## HADLEY'S TOWING JSP16-33 with Rezoning 18.715

Recommend to the City Council approval or denial of rezoning request from I-1 (Light Industrial) to I-2 (General Industrial) with a Planned Rezoning Overlay.

## PLAN REVIEW CENTER REPORT

### Planning Review

**CONCEPTUAL LAYOUT PLAN (NORTH)**  
CONCEPTUAL LAYOUT PLANS - PARCEL No. 22-17-101-006  
TOWNSHIP 10 N RANGE 7E  
SECTION 17  
CITY OF NOW, MICHIGAN

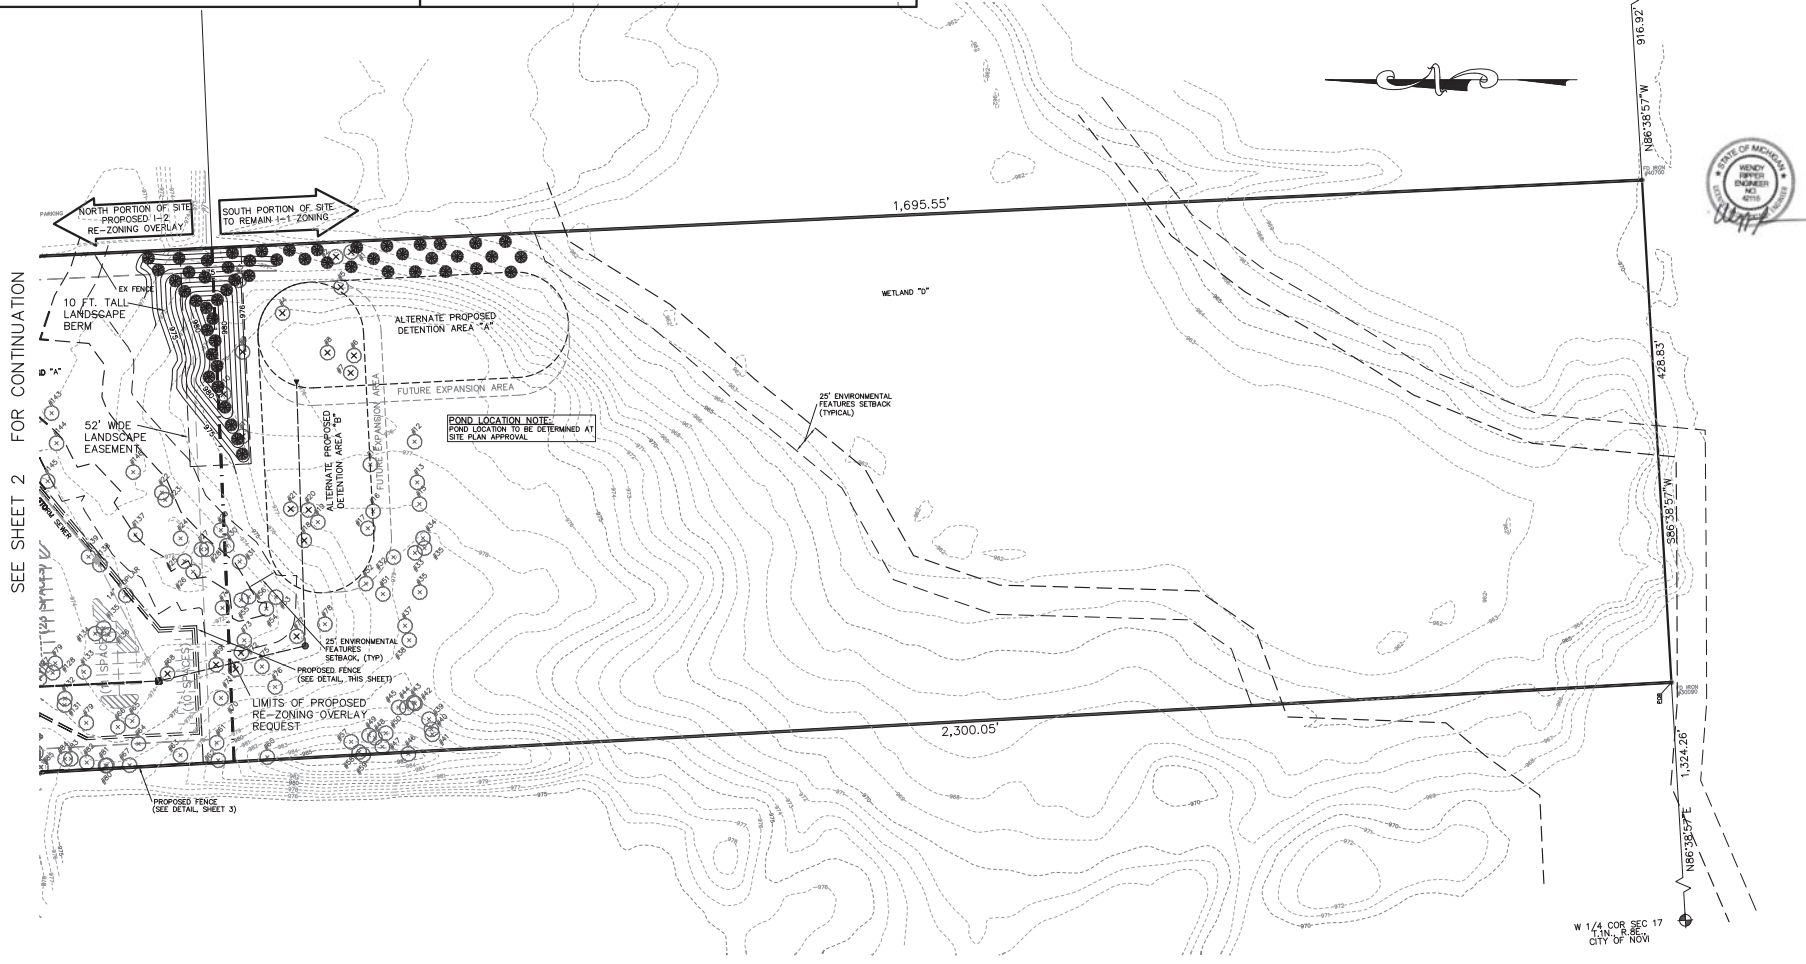
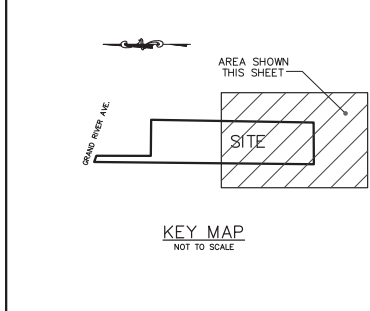
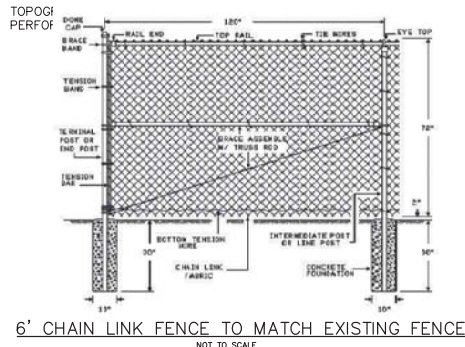
Soils are listed on Sheet 2.

2. Screening fence is proposed along the north property line to match the existing fencing along the eastern property line. The plan view note on Sheet 2 indicates that this fence is non-transparent.

Figure 1. City of Novi Regulated Wetland & Woodland Map (approximate project area is highlighted in red). Regulated Woodland areas are shown in green and regulated Wetland areas are shown in blue).

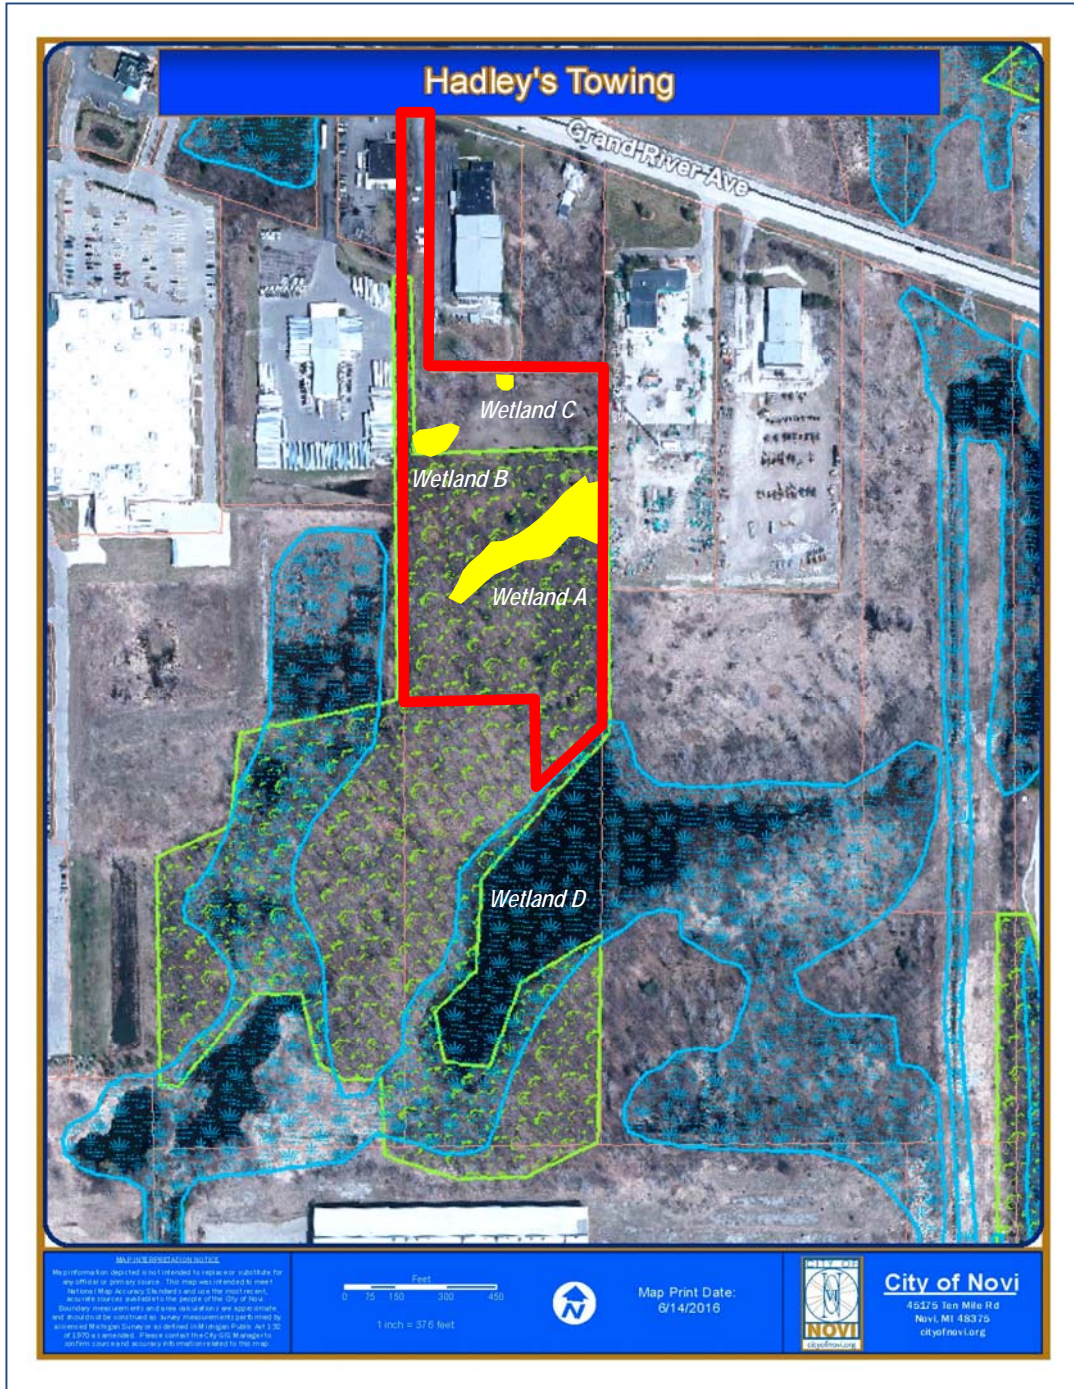
Based on our review of the Plan, Novi aerial photos, Novi GIS, the City of Novi Official Wetlands and Woodlands Maps (see Figure 1, attached) it appears as if this proposed project site contains City-regulated wetlands and woodlands. The City's wetland and woodland map shows that the overall property contains wetlands to the south. However, a review of aerial photos of the site, the proposed site plan, and previous site visits, the site contains four (4) total areas of wetland (Wetlands A, B, C, and D).

Figure 1. City of Novi Regulated Wetland & Woodland Map (approximate project area is highlighted in red). Regulated Woodland areas are shown in green and regulated Wetland areas are shown in blue).

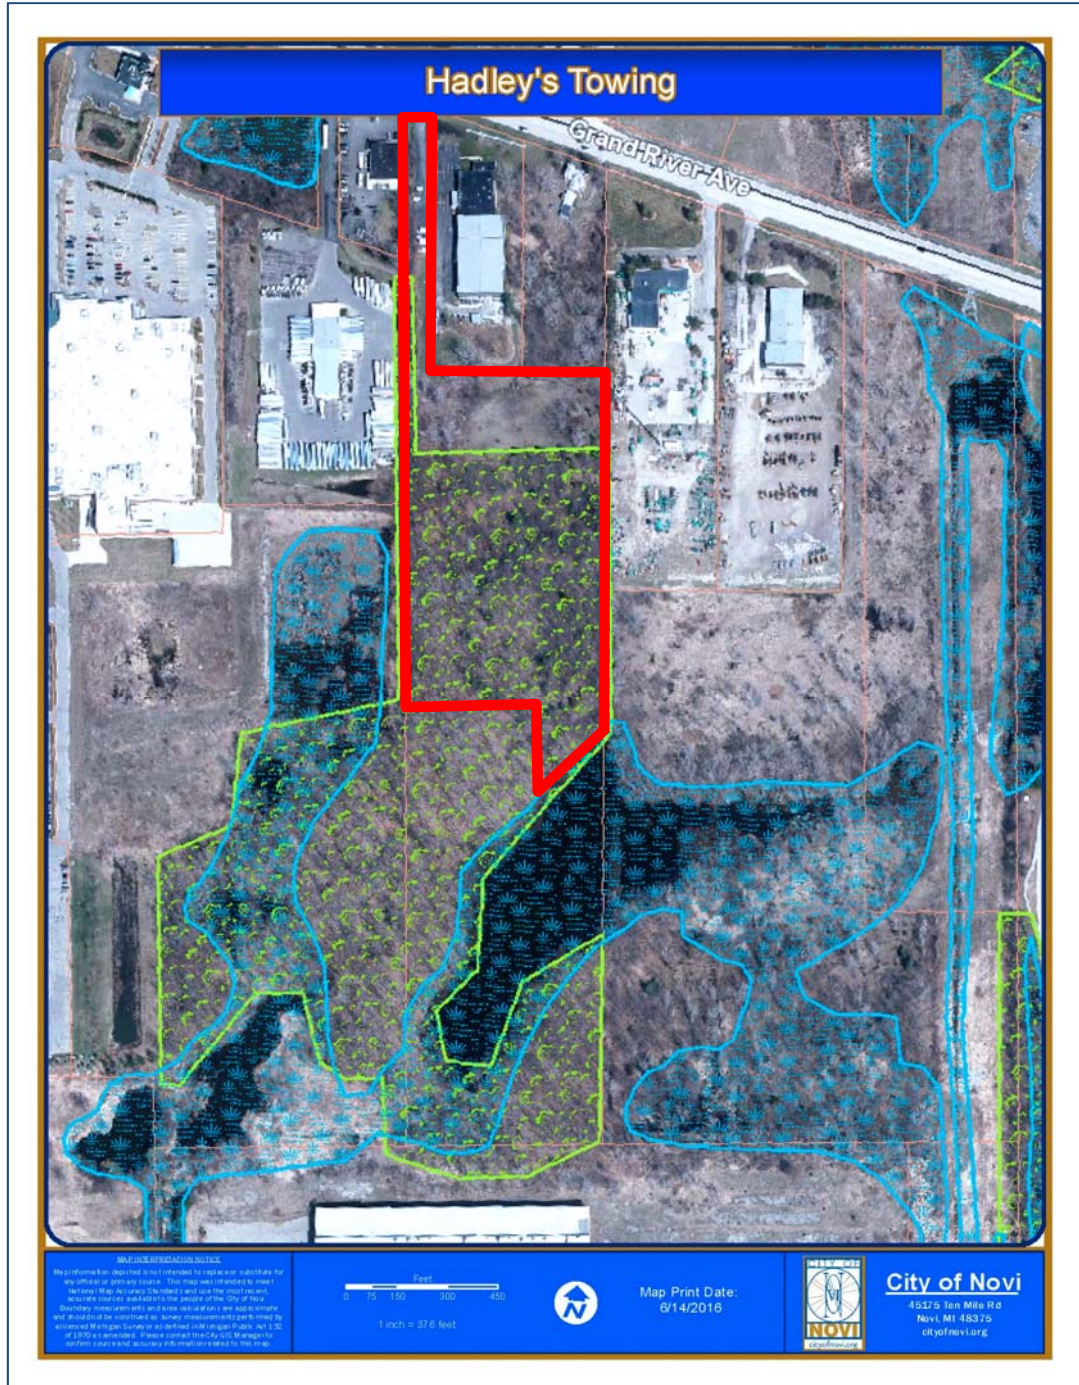
The site does contain areas noted as City of Novi Regulated Woodlands. The majority of the property contains Regulated Woodland (see Figure 1). The current plan includes a partial tree list and a partial list of the proposed tree removals. The plan notes that "*tree locations on south portion of site not available at time of concept plan submittal*". As such, the total impact to existing trees associated with the proposed detention basin and associated stormwater outfall pipe are not calculated on the Plan. The previously submitted concept plan stated that "*tree survey to be performed on south portion of property at the time of preliminary site plan submittal*".
